Subject: Collin County Healthcare Facility, Parking Garage, and Medical Examiners
PCO No. 063; RFI #237 and #254 ME CMU Wall Partition Overhead Bracing

Issue No. 063 - RFI #237 and #254 ME CMU Wall Partition Overhead Bracing Amount

RFI #254: ME - Post-Installed CMU Wall Overhead Bracing

EXAMPLE MASONRY PARTITION WALL
DETAIL FROM ME-A0.11 OF SHOWING
REQUIRED BRACING AT TOP OF WALL

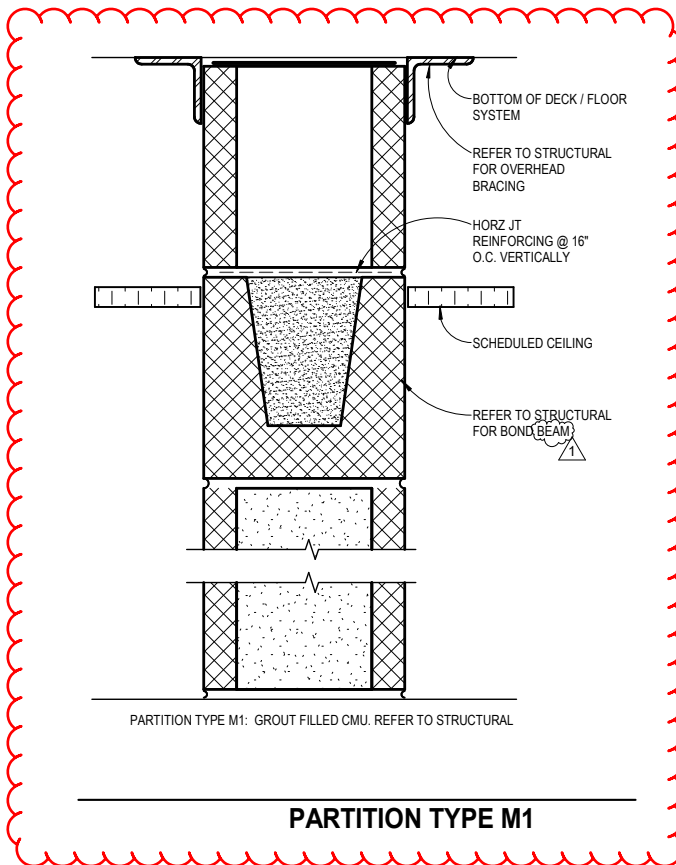
SEE ATTACHED POST-INSTALLED CONNECTION DETAILS FOR THE CMU WALL OVERHEAD BRACING CONDITIONS BASED ON THE OVERLAY IN THE RFI. PER SECTION H.1 ON ME-S0-01, MASONRY WALLS SHOWN ON THE ARCHITECTURAL AND STRUCTURAL DRAWINGS REQUIRE BRACING AT THE TOP OF THE WALLS. NOTE THAT BRACING ANGLES AT TOP OF WALL ARE CONCEPTUALLY SHOWN IN ARCHITECTURAL DOCUMENTS FOR ALL MASONRY PARTITION WALL ON SHEET ME-A0.11.

CMU TOP POST-INSTALLED CONNECTION
BETWEEN WIDE FLANGE BEAMS.

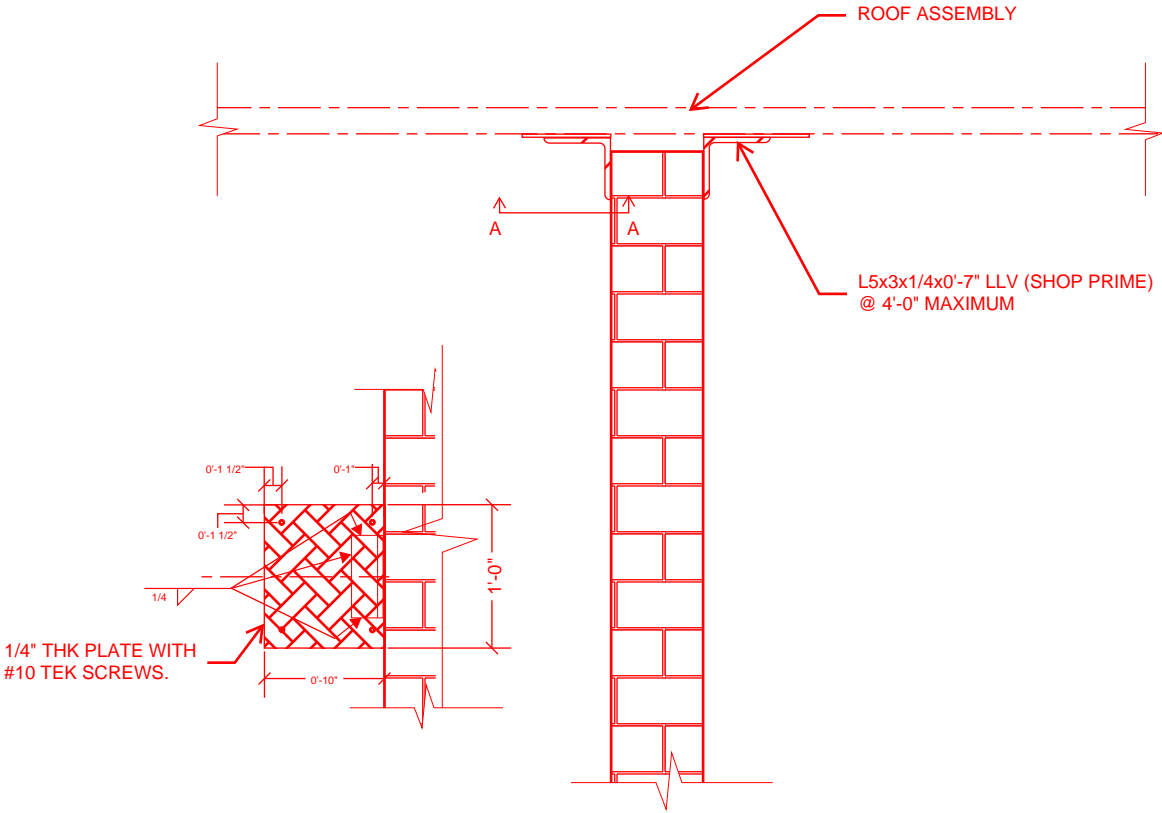
1. AT CONTRACTOR'S OPTION, ACCEPTABLE TO USE ONE 1/4"x5" Vx10" H BENT PLATE IN LIEU OF THE ANGLE AND 1/4" THK PLATE SHOWN.

CMU TOP POST-INSTALLED CONNECTION WHERE WALL CLOSE TO THE WIDE FLANGE BEAM.

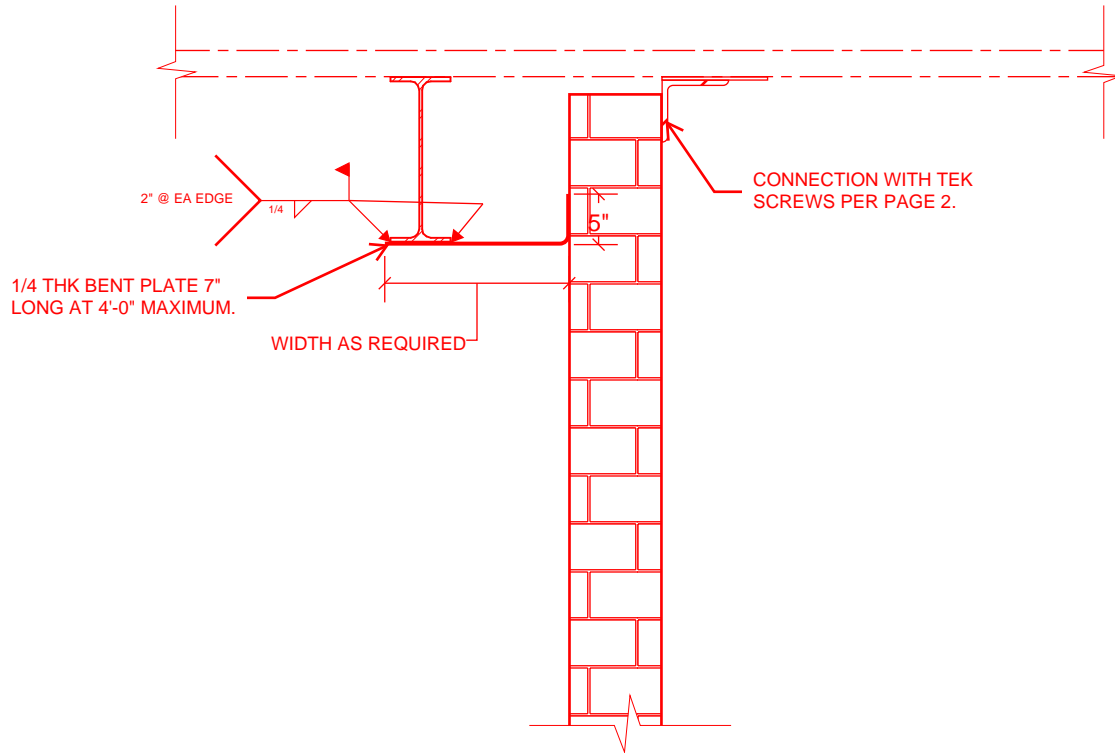
1. THIS DETAIL IS TO BE USED ONLY IF INTEGRAL INTERSECTING SUPPORT WALLS AT EACH END EXCEED A SPACING OF 36 TIMES THE NOMINAL WALL THICKNESS.

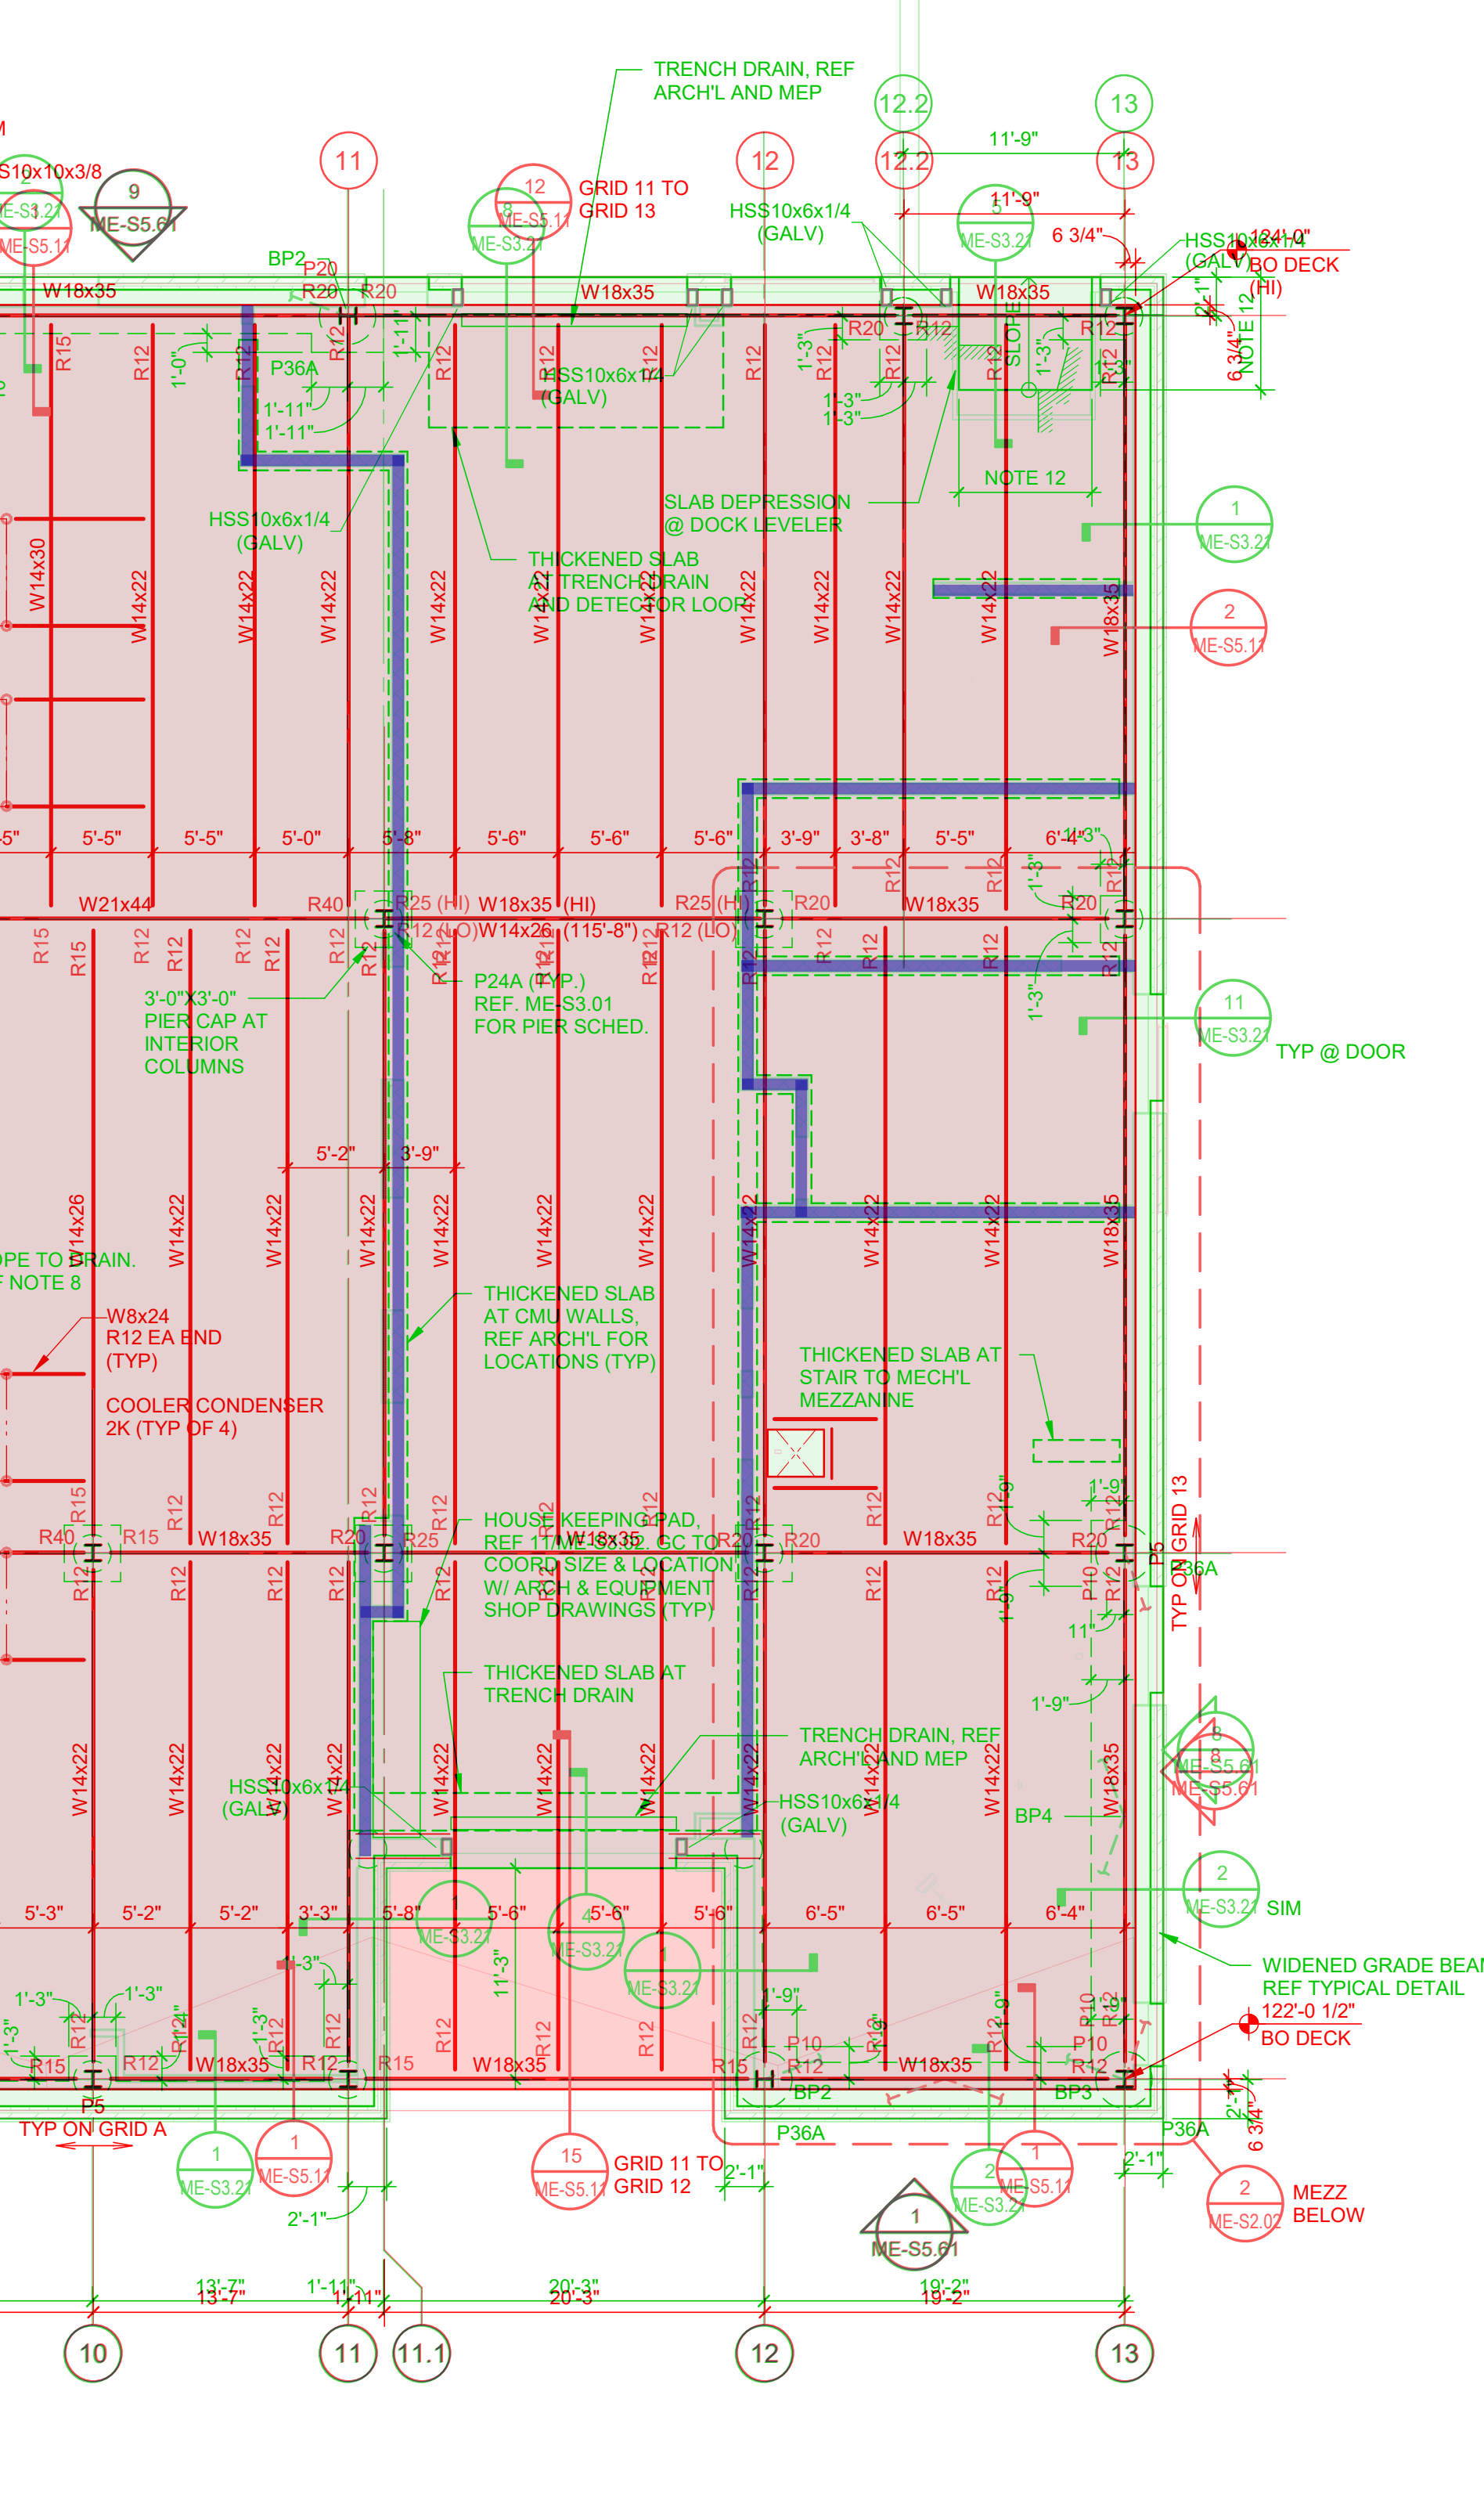
Please see the attached rough overlay of our interior CMU walls in the ME building with respect to the roof structure. All of the walls, with the exception of the ones directly underneath the Mezzanine, span to the high roof area. The purpose of this RFI is to capture a post-installed solution for any necessary CMU wall overhead bracing. The original RFI 237 did not at the time of submission clarify our field conditions specifically. We can confirm this was something we observed after the fact, with the fact that our CMU walls spanned large distances with no overhead bracing details to reference in our ME CMU wall details.

The previous RFI 237 response and details provided is only able to be constructed with the removal of previously completed construction, but this may incur additional costs. This RFI is looking to achieve an alternative post-installed solution to reduce cost implications.
